**RTW 2023**  
**Airbus**  
**A330CEO**  
**ATA 36**

Liebherr-Aerospace Toulouse SAS

# Engine Bleed Not Closed – Airbus / Liebherr ISE Status

# HPV NOT OPEN

**PRV 6764B080000 &  
6764C010000**

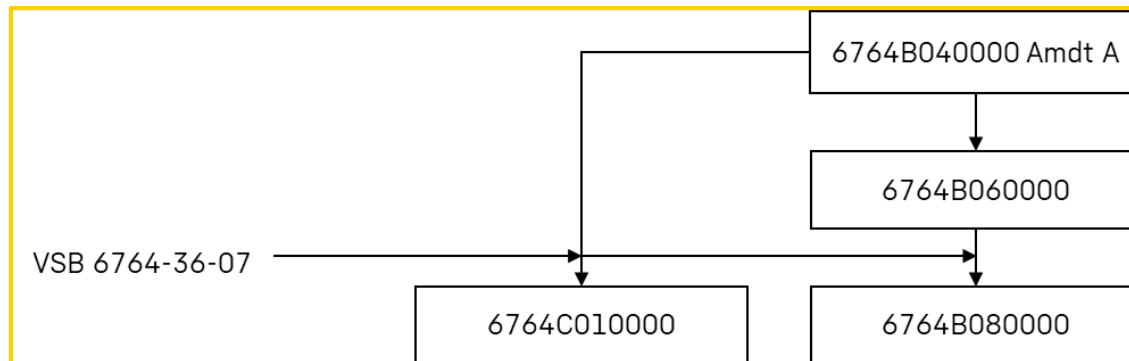
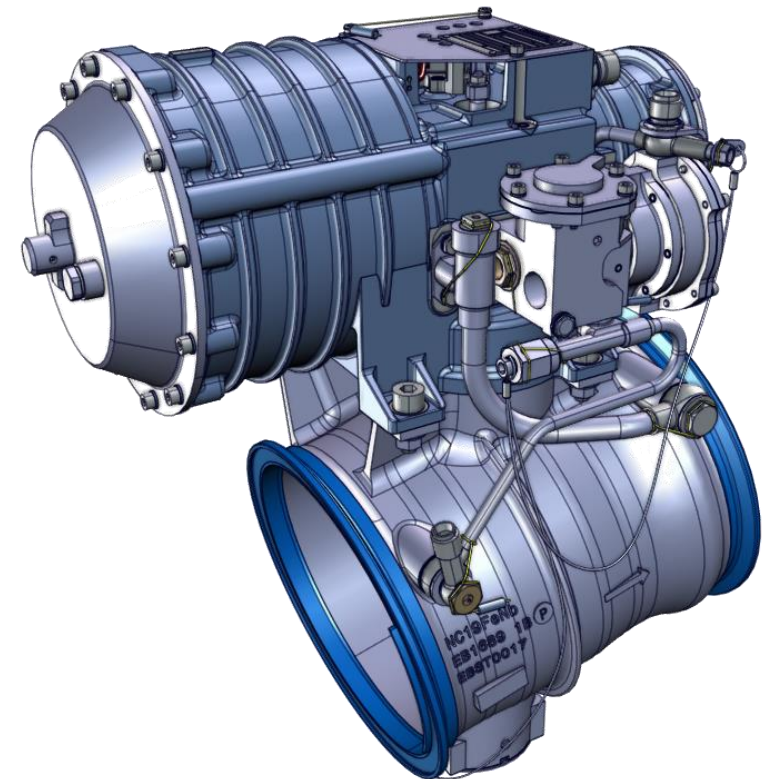
Airbus request for PRV modification to make the PRV able to re-open at high upstream pressure (for **Take-Off, Bleed OFF & APU Bleed ON** operations for specific airlines).

Design modification of Regulation sub-assy clapper and clapper seat.

Allow re-opening of the PRV in case of upstream pressure up to 27.5 barg.

VSB 6764-36-07 available since March 2023

6763C080000  
Solenoid assy 93003-0300

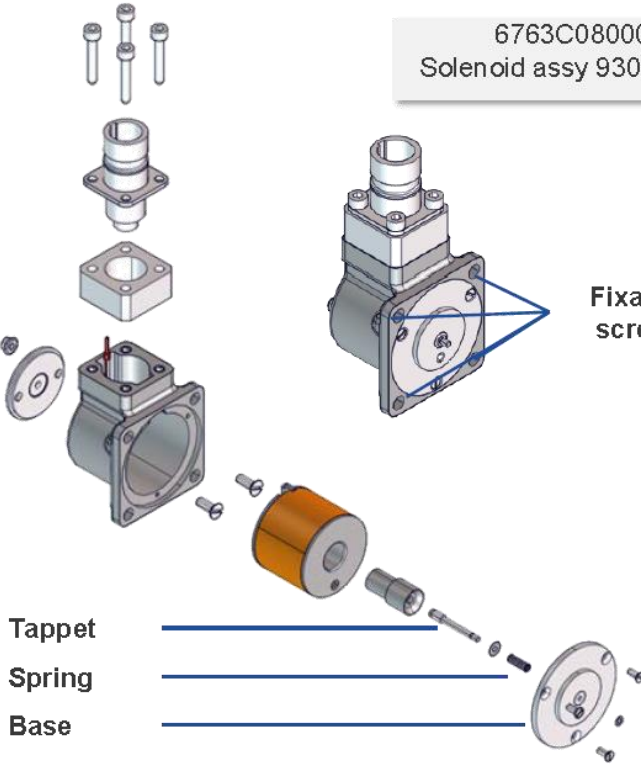
The Solenoid assy was identified as a contributor to the HPV opening occurrences.

Fixation screws

Tappet  
Spring  
Base

Solenoid assy	Maintenance Mitigation	Design Mitigation (Product Improvement)
Fixation screws	After solenoid cleaning and re-assembly on the HPV, ensure screws are correctly torqued	Replacement of the 4 screws by socket head screws and installation with lock-wire
Tappet 93003-42	Cleaning or replacement pending visual inspection	Manufacturing tolerance improvement
Spring S100-687	Replacement	Design unchanged
